Waitaha Hydro Power Review of Intake Engineering and Fish Passage

Waitaha Hydro Expert Consenting Panel

Report prepared for: Waitaha Hydro Expert Consenting Panel
Report prepared by: Paul Morgan, FEngNZ, CPEng, BE (hons), BSc

Report reference: 2501-A

Figure 1 Percentage of time residual flow occurs for a take ranging from 0 to 23 m³/s (using all months).

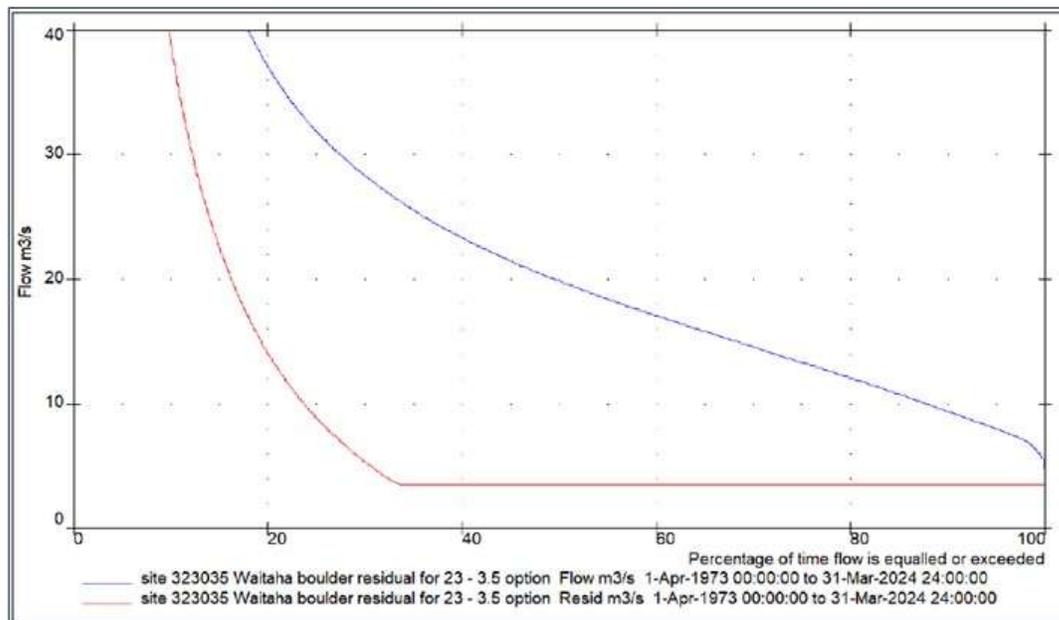
The operation of the scheme results in a significant change to the flows downstream of the intake weir to the tailrace. The maximum flow for 66% of the time will be in the order of 3.5m³/s with a little more from minor tributaries for part of that river section. Figure 1 shows the Flow Duration Curve at the Intake from the Hydrology Report. The flows will be significantly less in that section for 90% of the time. But more importantly for at least 66% of the time the flows will be lower than the lowest natural flows and well below the MALF.

Trout would need to swim through the environmental flow release but that appears unlikely given the velocities I have calculated through that structure but if trout are waiting immediately downstream of the intake when a higher flow event arrives and drowns out the intake (information from applicant indicated this occurs at 150m³/s) then it may then be possible for trout to move upstream when that occurs.

Without any detailed assessment and based on limited information the risks of eels getting upstream would seem high but trout much lower. It is not clear how eel could be excluded in this scenario and therefore introduces a potential effect on the kōaro upstream given currently they are the only fish present. The surveys have shown that kōaro are present in more limited numbers upstream due to natural barriers. Any introduction of other fish species such as eel may be a concern given the already limited numbers of kōaro.
